2191002

RE: Response to Submissions, Eastern Creek Quarter Stage 3 Concept Plan (SSD-10457)

Ethos Urban has prepared this letter on behalf of Frasers Property Australia (Frasers) in response to the Department of Planning, Industry and Environment's (DPIE) letter dated 11 March 2021 and the associated submissions received during the exhibition period of SSD-10457 relating to the Eastern Creek Quarter Stage 3 Concept Plan.

Figure 2 Extract of the Rooty Hill Precinct 3 Conservation Area

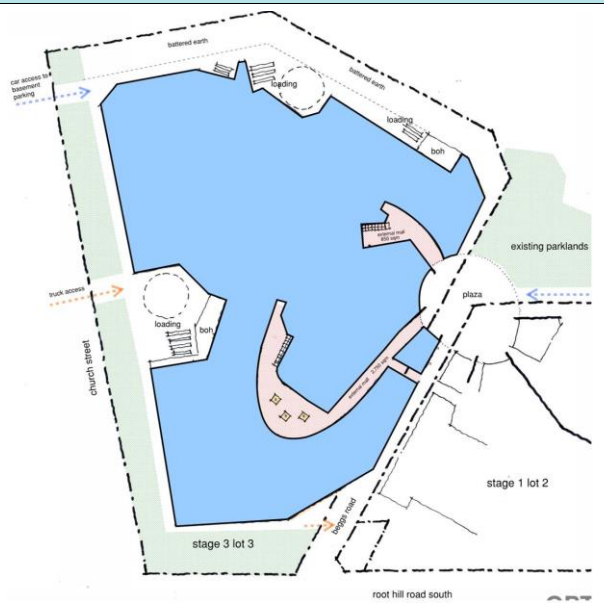
In accordance with the objectives of Precinct 3, a significant portion of the vegetation within Lot 3 has already been flagged for removal through the approval of the previous Concept Plan. This vegetation, as well as the additional vegetation now proposed to be removed, is not located within the protected bushland corridor which runs along the western edge of the Precinct or any other conservation area. Rather, the vegetation is fragmented from other patches of CPW and is located within the Business Hub Land which is identified for commercial development (refer to the extract of Precinct 3 at **Figure 2**).
